**HAM4-L1**  
**D0900421**

D1003349 AOS SR2 SCAPER  
BAFFLE IS A WORK IN PROGRESS.

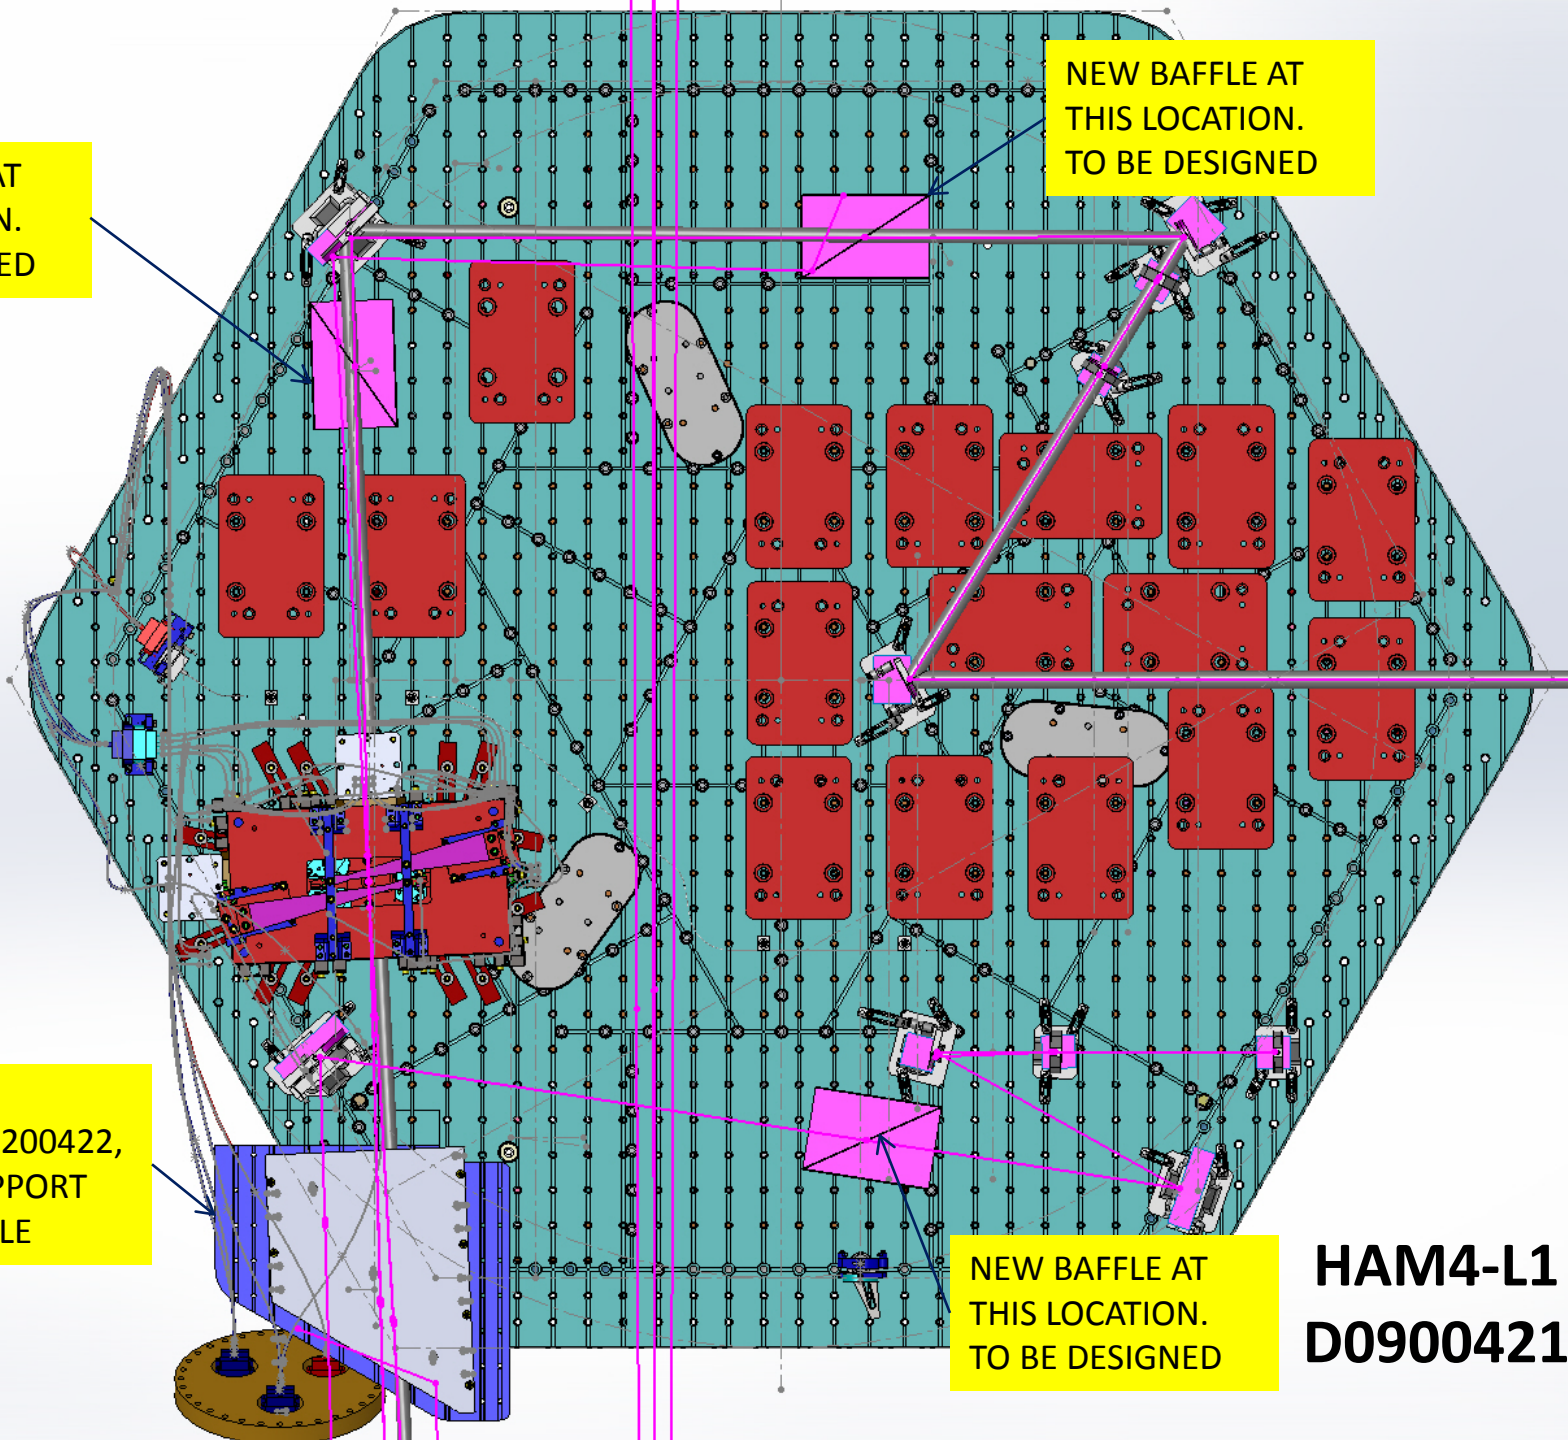
NEW Baffle at this location. To be designed

NEW Baffle at this location. To be designed

NEW TABLE EXTENSION D1200422, ADDED TO SUPPORT SCRAPER Baffle

NEW Baffle at this location. To be designed

**HAM4-L1**  
**D0900421**

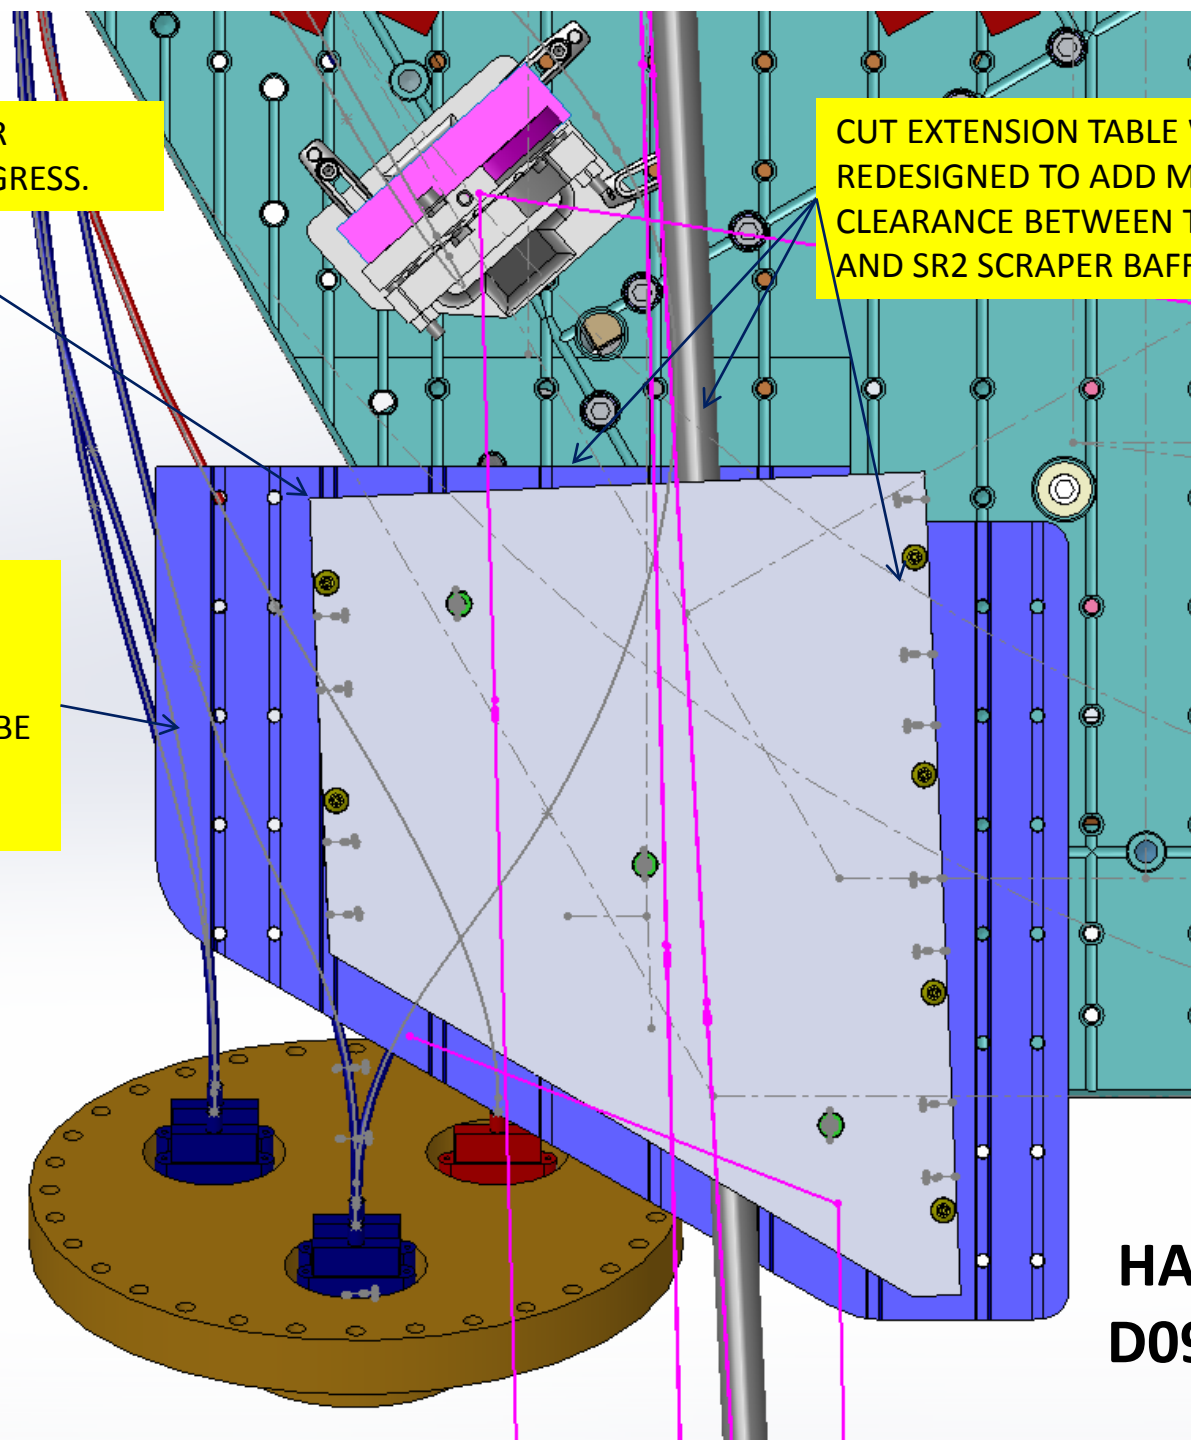
CUT EXTENSION TABLE WILL BE  
REDESIGNED TO ADD MORE  
CLEARANCE BETWEEN TCS ITEM  
AND SR2 SCRAPER BAFFLE.

DOG CLAMPS ELIMINATED.  
D1100365 SPACER WILL BE  
ATTACHED TO EXTENSION  
TABLE, THEN BAFFLE WILL BE  
ATTACHED TO SPACER  
INTERNALLY.
